UNIVERSITY OF CALIFORNIA, IRVINE

**Re: Docket 50-326 Relicense, RAI dated April 5, 2011 (TAC ME1579),
additional response material - extension granted to August 1st, 2011.**

University of California – Irvine (UCAI)
License No. R – 116
Docket No. 05000326

Response to RAIs Dated April 5, 2011 (TAC ME1579), Additional Response Material –
Extension Granted to August 1st, 2011

Figure 3-2 Rowland Hall roof exhaust fan Axijet S 6600 details

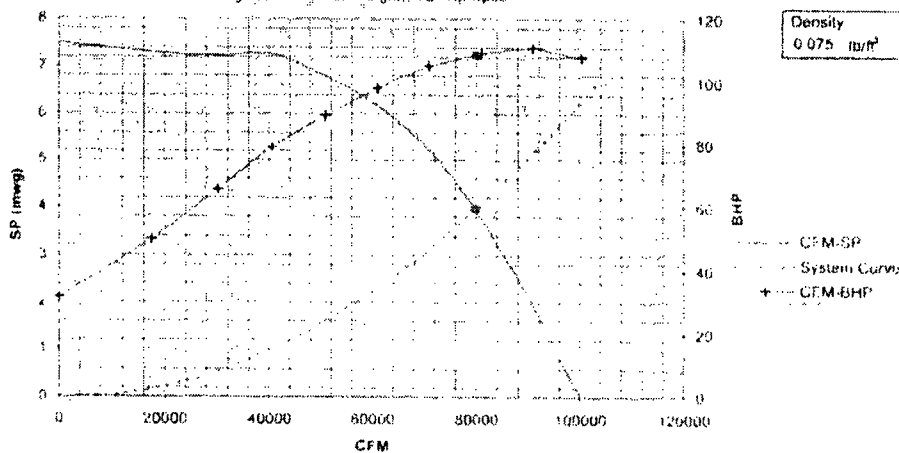
The ventilation system (SAR Section 3.6) discharges the emergency purge exhaust into the main building exhaust which has three exhaust fans designed to create a flow of $3 \times 80,000$ cfm, further diluted to $3 \times 128,000$ cfm at a height of 120 feet above the building roof by means of Axijet® structures. From that point, natural dispersion, aided by the jet stream, will further dilute the effluents.

From the above, it is reasonable to assume a conservative dilution of the exhaust effluent by a factor of $384,000/240 = 1.6 \times 10^3$. Using this, and assuming no climatic or other dilution outside the building exhaust flow, the maximum dose to an individual's thyroid may be calculated.
